# Mitchell Park Horticultural Conservatory Domes

Peer Review — Precast and Cladding

## Peer Review

# WJE Considerations for Enhancement

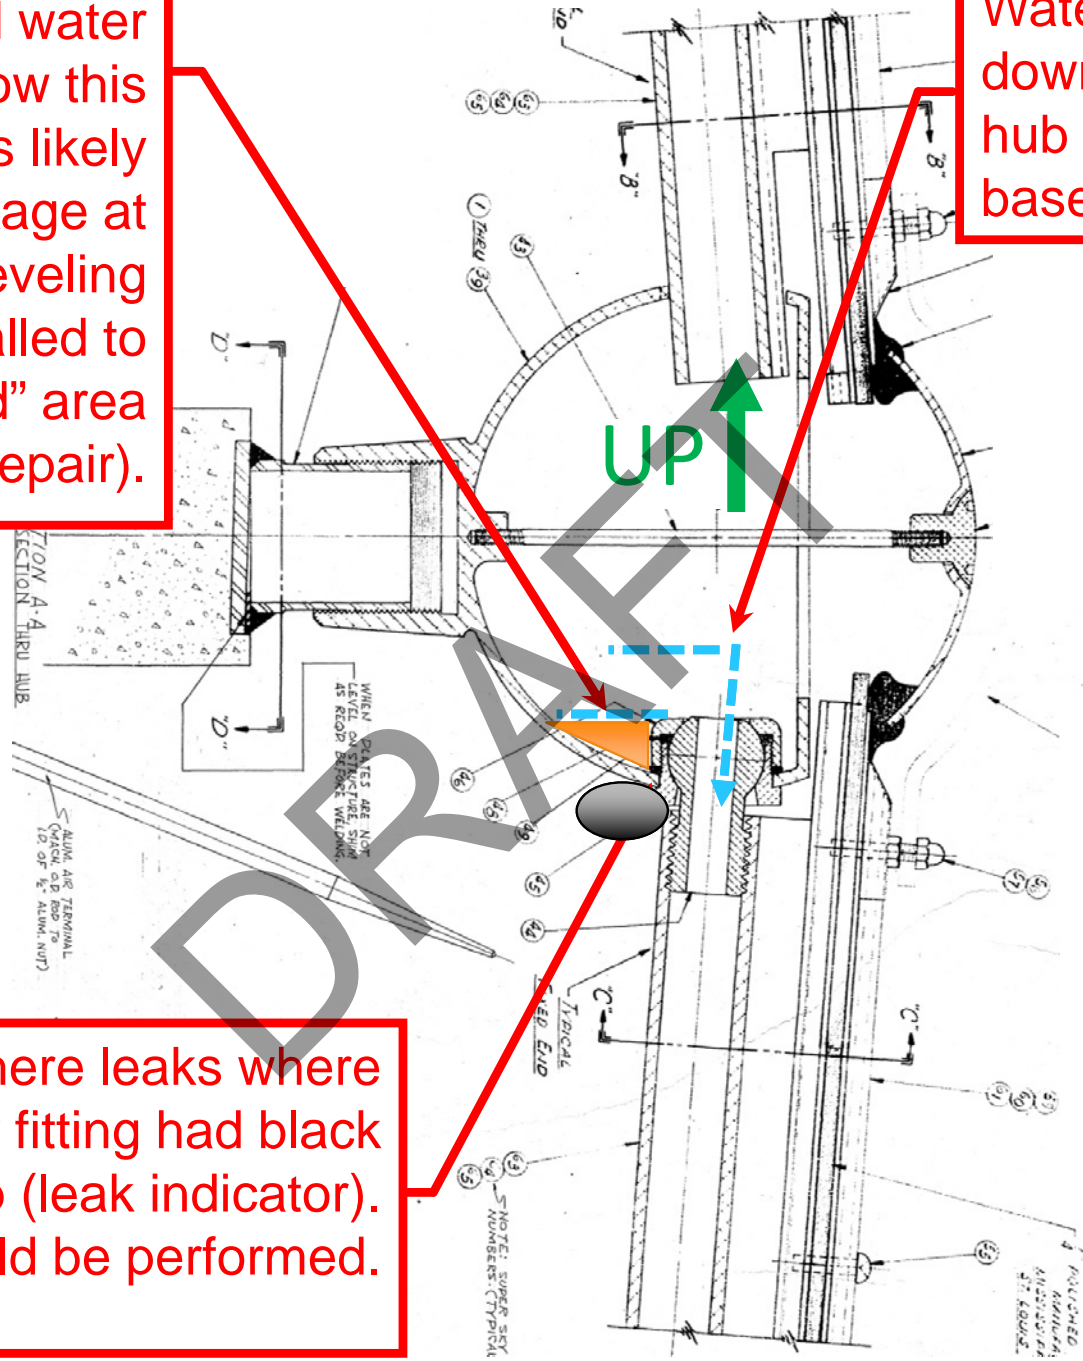
GRAEF observed water sitting in the hub below this elevation, which is likely causing water leakage at fittings. A self-leveling sealant can be installed to fill in the “depressed” area (GRAEF repair).

At locations where leaks were observed, the rafter fitting had black material build-up (leak indicator). Target repairs could be performed.

New pressure cap to enhance water tightness

New Sealant joint (wet seal)

New gasket

Water can then flow down the rafter at each hub and out at the base of the dome
